MURPHY - KELLER
EDUCATIONAL CENTER

HEIFER
INTERNATIONAL
CENTER

CONTENTS:
ENLARGED PLAN

SHEET NUMBER:
P101K

ENLARGED KITCHEN EQUIPMENT PLUMBING FIRST FLOOR PLAN (1)
SCALE: 1/4"=1'-0"

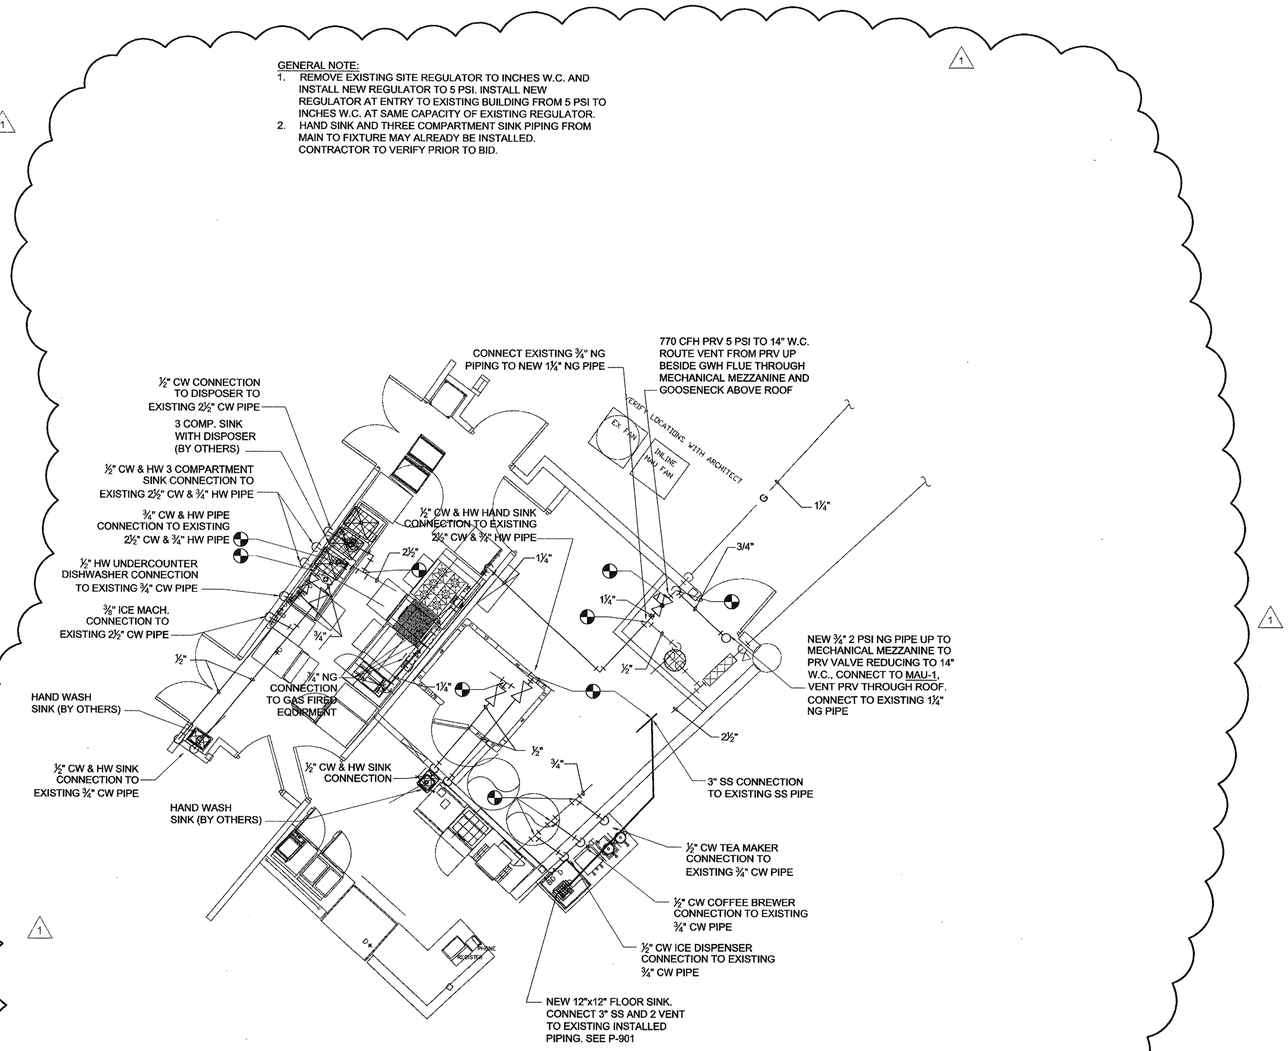
GENERAL NOTE:
1. REMOVE EXISTING SITE REGULATOR TO INCHES W.C. AND INSTALL NEW REGULATOR TO 5 PSI. INSTALL NEW REGULATOR AT ENTRY TO EXISTING BUILDING FROM 5 PSI TO INCHES W.C. AT SAME CAPACITY OF EXISTING REGULATOR.
2. HAND SINK AND THREE COMPARTMENT SINK PIPING FROM MAIN TO FIXTURE MAY ALREADY BE INSTALLED. CONTRACTOR TO VERIFY PRIOR TO BID.
